Springwell Solar Farm

Written Summary of Oral Submissions
at Issue Specific Hearings 2, 3 and 4

EN010149/APP/8.22
Revision 1
Deadline 3
August 2025
Springwell Energyfarm Ltd

TITLE:
Plan 1a – Cumulative Solar Development and
NCA 47 (Operational and Consented Projects Only)

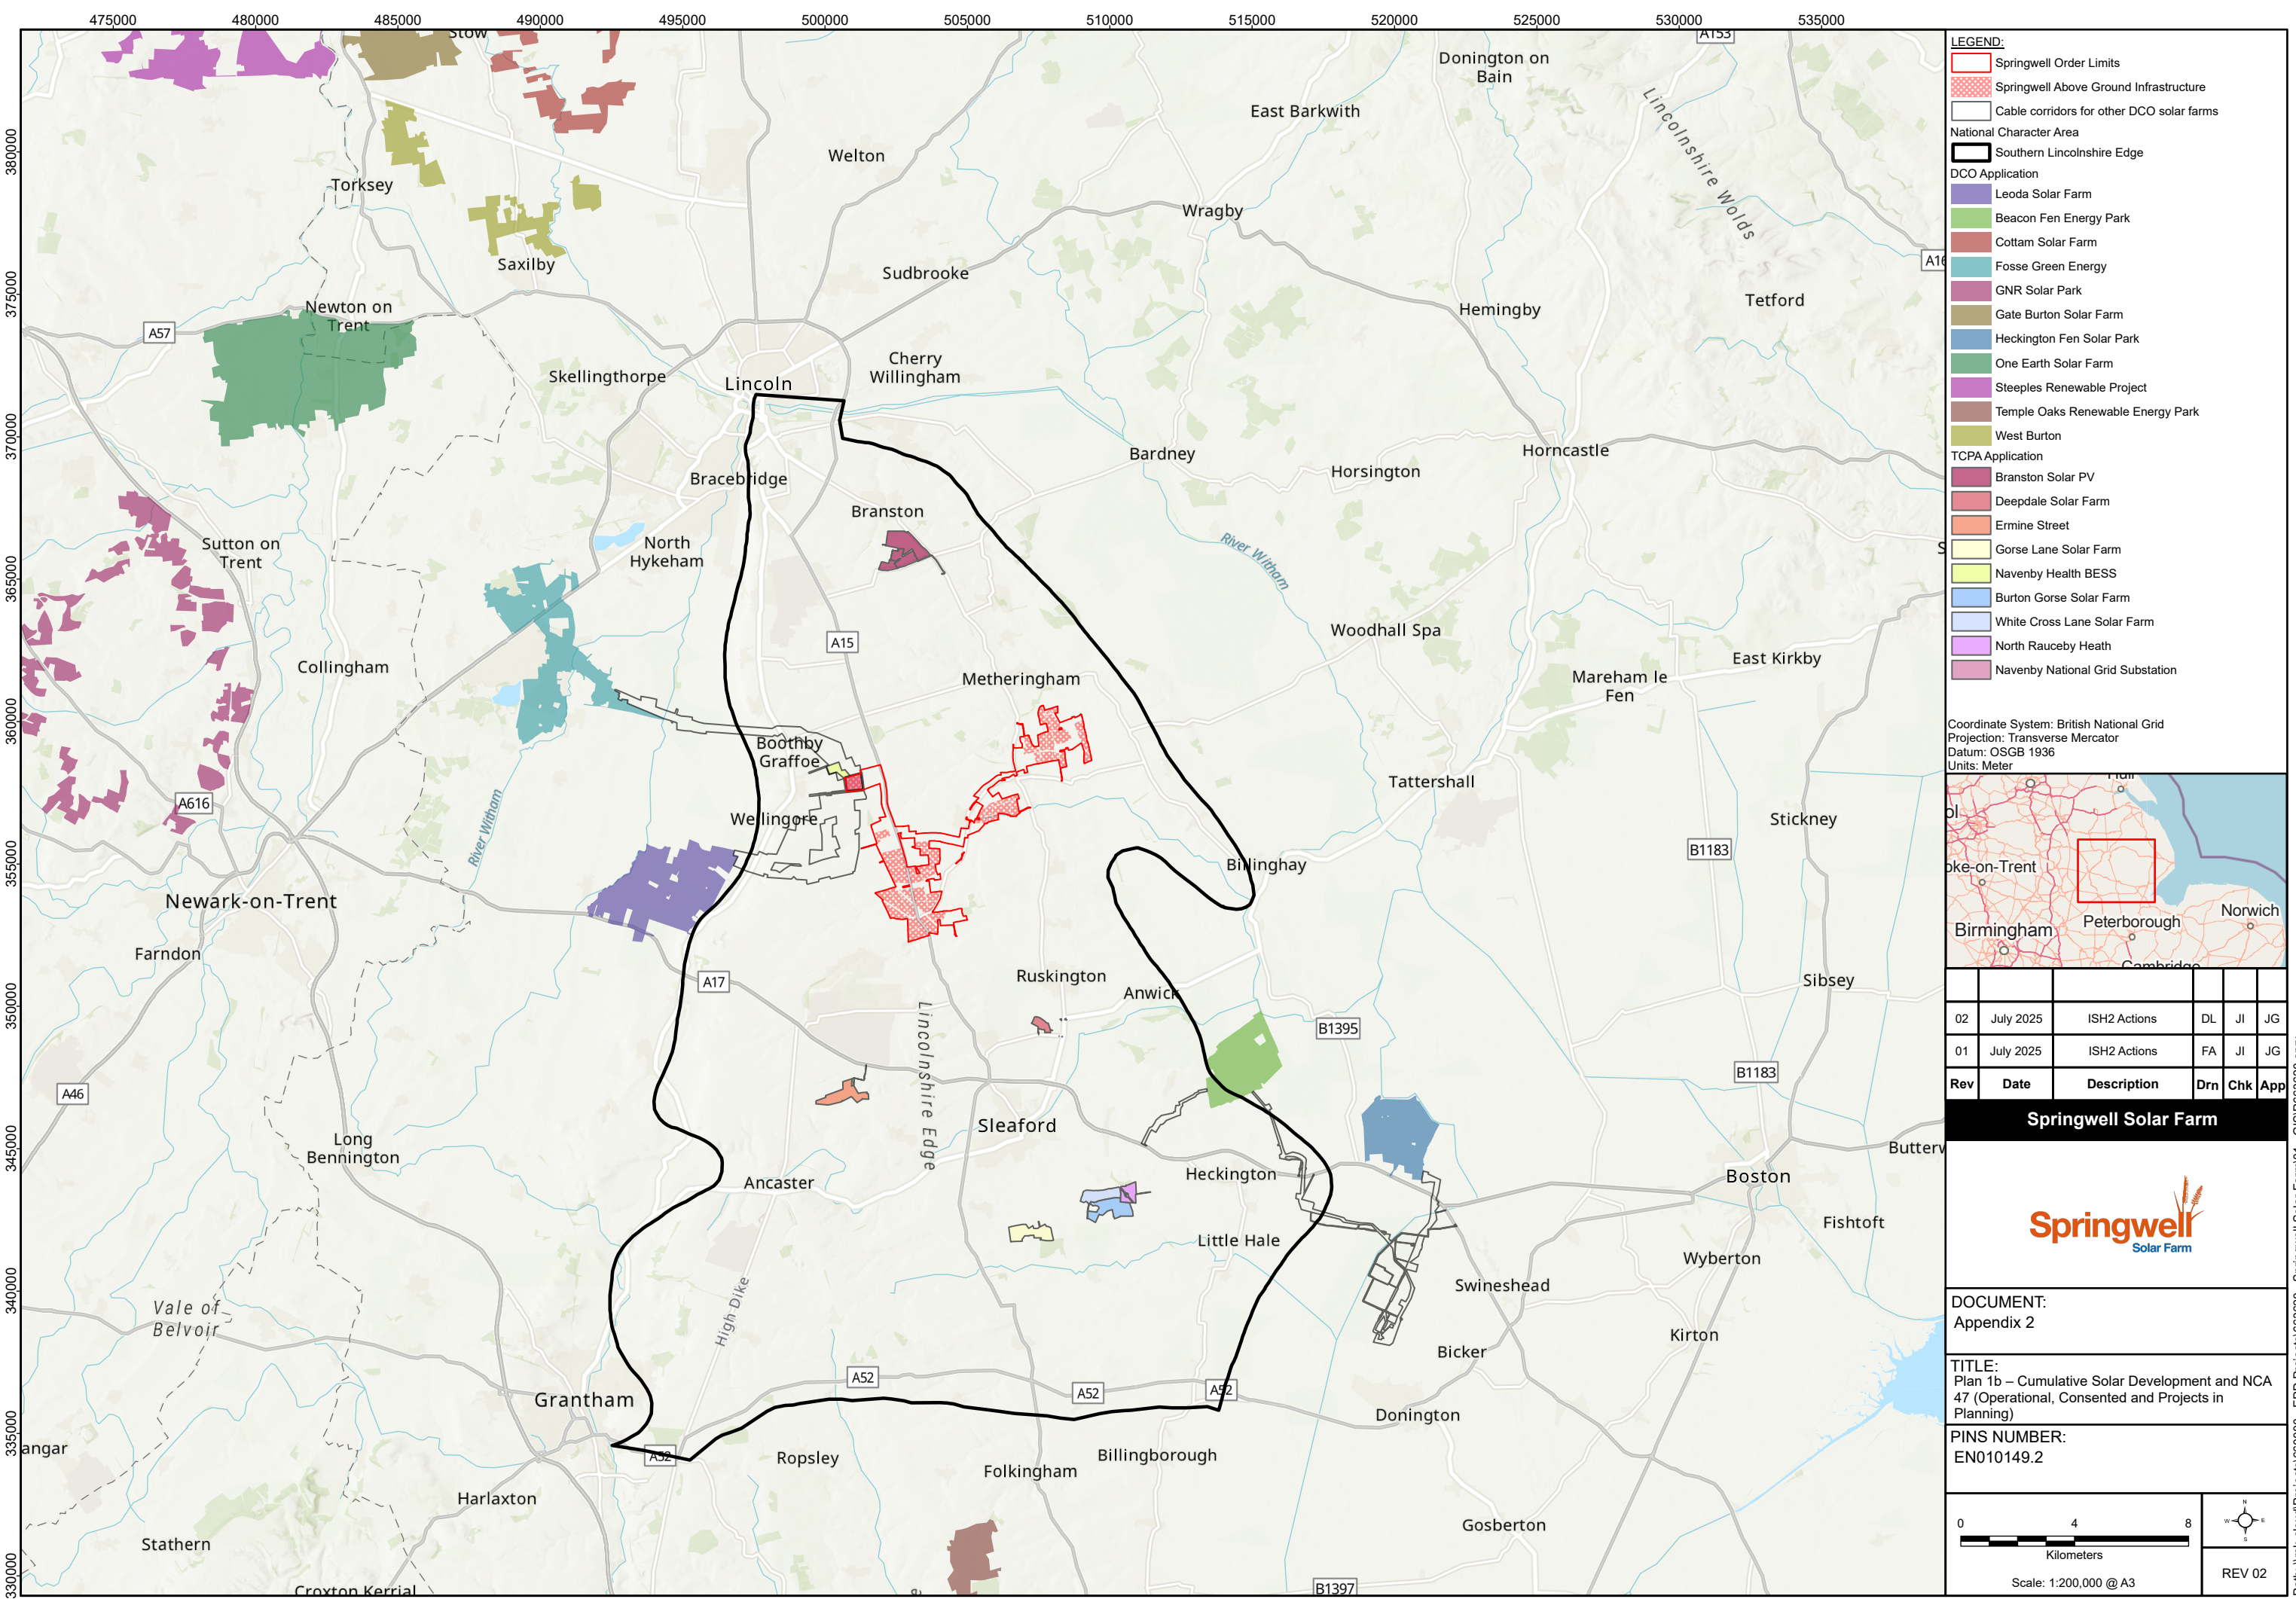
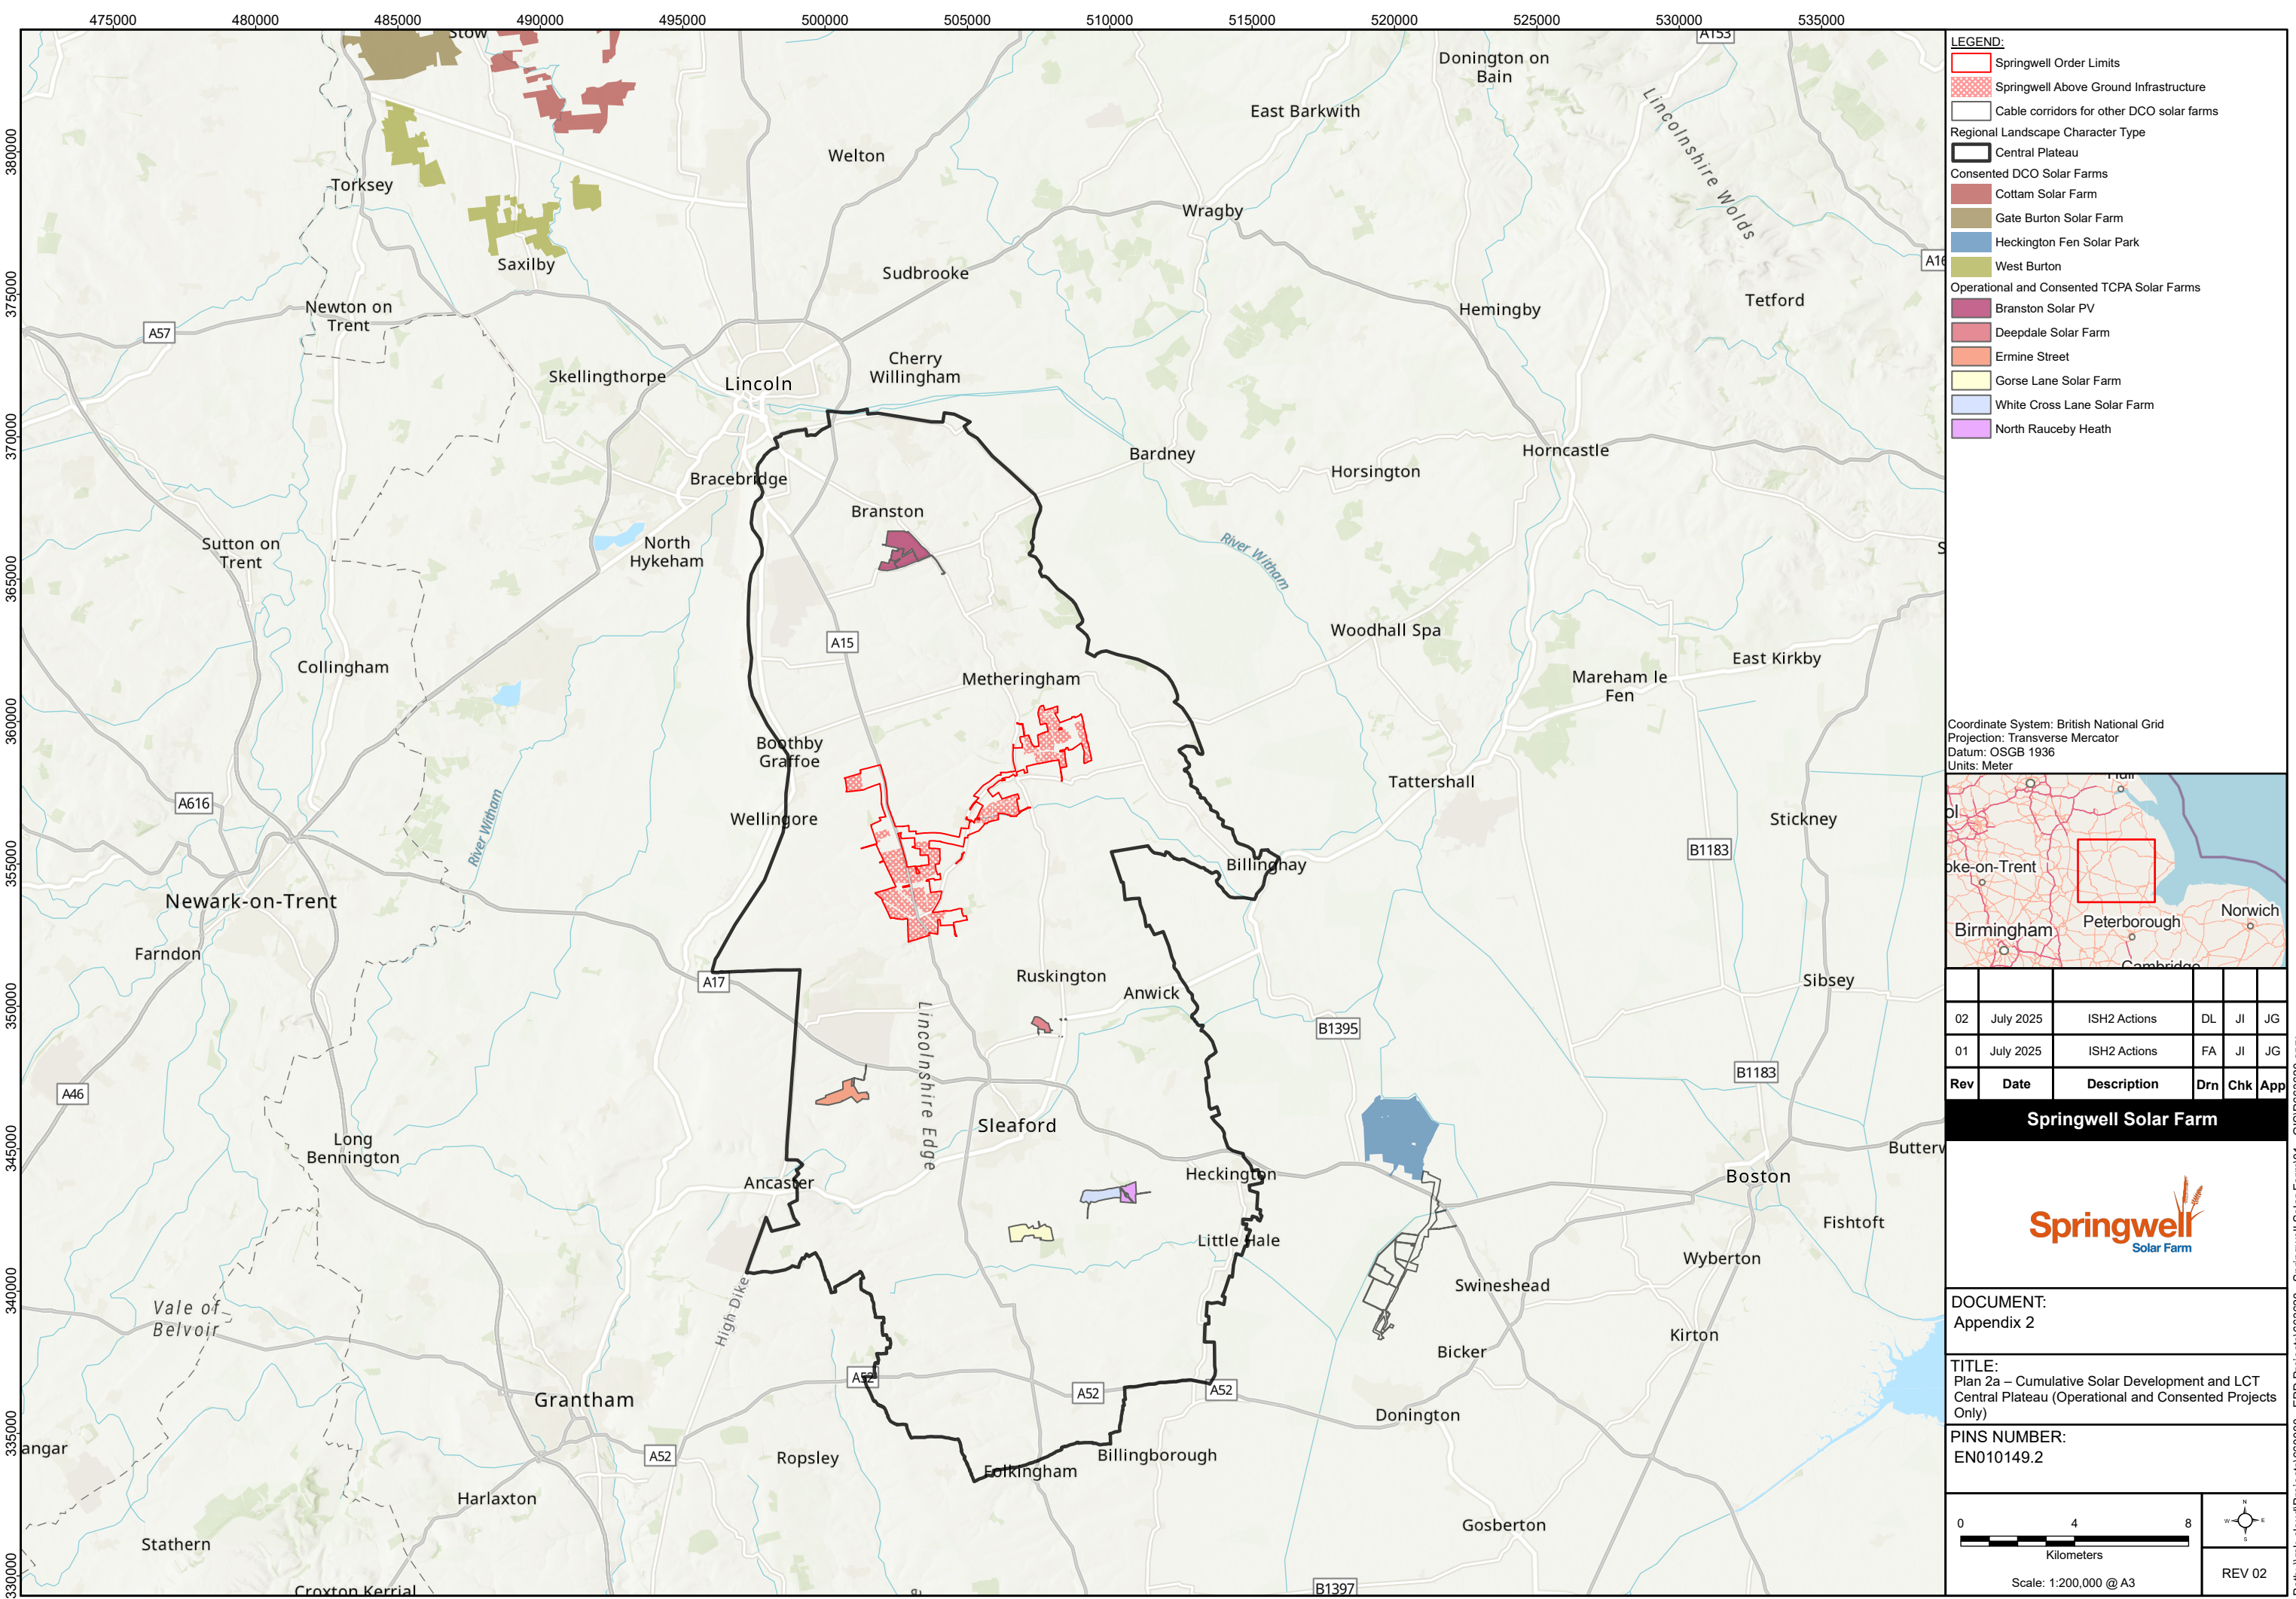
#	Agenda item	Written summary of Applicant's oral submissions at ISH 2
		<p>The ExA highlighted that Plan 3 of Appendix 2 of the Response to First Written Questions (ExQ1) [EN010149/APP/8.14] [REP1-071] do not show Deepdale Solar Farm, Branston and Ermine Solar Farms in LCA 7, Gorse Lane, White Cross Lane and North Rauceby Heath in LCA 11. The Applicant should add on the map if the solar farms on the map show existing or proposed Town and Country Planning Act or Nationally Significant Infrastructure Projects (NSIP). Mr John Ingham, Landscape Planning Director at RSK, confirmed the Applicant will update this plan at Deadline 3.</p> <p>Post hearing note: An updated plan has been provided as an Appendix to the Applicants Response to Action Points – ISH2, ISH3 and ISH4.</p> <p>In response to a question from the ExA to Lincolnshire County Council (LCC) about if large scale solar will become a defining characteristic of the area, Mr Griffiths responded that the impact of the Proposed Development is a localised impact, rather than an impact on the wider area.</p> <p>The ExA asked the Applicant if large scale solar were to be viewed in a similar manner to RAF installations, would it become a key characteristic of the National Character Area (NCA) and change the landscape character. Mr Ingham responded that Springwell will become a local characteristic feature. He continued that the southern Lincolnshire edge character description prepared by Natural England was prepared before any solar farms in the NCA were constructed, so solar farms have subsequently become a feature of the NCA. The Applicant agrees that solar farms would become a locally characteristic feature of the NCA, but they are not a defining characteristic of the NCA. Agricultural land use will remain by a considerable margin the defining land use of all character levels.</p> <p>In response to LCC's concerns about the extent of solar development across North Kesteven and across Lincolnshire, Plan 1: Cumulative Solar Development and National Character Area 47, Appendix 2 in the Response to First Written Questions (ExQ1) [EN010149/APP/8.14] [REP1-071] was shown on screen and Mr Griffiths explained that no large-scale solar projects will be sited and visible within the NCA47 other than the Proposed Development. Mr Ingham clarified that even though the order limits of Fosse Green Energy and Leoda Solar Farm extend to within the NCA boundary, the areas of the projects on Plan 1: Cumulative Solar Development and National Character Area 47, Appendix 2 of the Response to First Written Questions (ExQ1) [EN010149/APP/8.14] [REP1-071] that are bereft of colour demonstrate that these are underground</p>

Action Point	Applicant's Response
Action Point 1: To provide overall % of area solar development and a revised Plan 3 of Appendix 2 of the Applicant's response to ExQ1 of all combined solar development within the landscape character areas Central Plateau LCT, LCA 7 and LCA 11. The Applicant should add on the map if the solar farms on the map show existing or proposed TCPA or NSIPs.	<p>The Applicant has updated Plans 1, 2 and 3 of Appendix 2 to the Response to First Written Questions (ExQ1) [EN010149/APP/8.14] [REP1-071], which have been appended to this document. In revising these plans it came to light that the Mareham Lane TCPA application (previously shown on Plans 1 and 2) was refused planning permission in March 2025. No appeal has been lodged against the refusal and therefore this site has been removed from all three plans for consistency. Conversely it has also been noted that a new TCPA solar farm application known as Burton Gorse Solar Farm was submitted on 26 March 2025. This has therefore been added to all three plans.</p> <p>In order to provide clarity on which projects are operational/consented and those which are in planning but not consented, two versions of each plan have been prepared. Plan 'a' in each case shows only those site (TCPA or NSIP) which are operational or consented. Plan 'b' in each case shows these sites plus others that are in planning but not yet consented.</p> <p>The updated figures are therefore:</p> <ul style="list-style-type: none"> Plan 1a – Cumulative Solar Development and NCA 47 (Operational and Consented Projects Only) Plan 1b – Cumulative Solar Development and NCA 47 (Operational, Consented and Projects in Planning)

Action Point	Applicant's Response												
	<ul style="list-style-type: none"> Plan 2a – Cumulative Solar Development and LCT Central Plateau (Operational and Consented Projects Only) Plan 2b – Cumulative Solar Development and LCT Central Plateau (Operational, Consented and Projects in Planning) Plan 3a – Cumulative Solar Development LCAs (Operational and Consented Projects Only) Plan 3b – Cumulative Solar Development and LCAs (Operational, Consented and Projects in Planning) <p>The table below summarises the total % of land area in the relevant NCA/LCT/LCAs that would be occupied by above ground solar infrastructure taking account of the Springwell Solar Farm, National Grid Navenby Substation and other TCPA/NSIP solar projects. The figures are broken down further into the % area occupied by operational or consented projects and those in planning.</p>
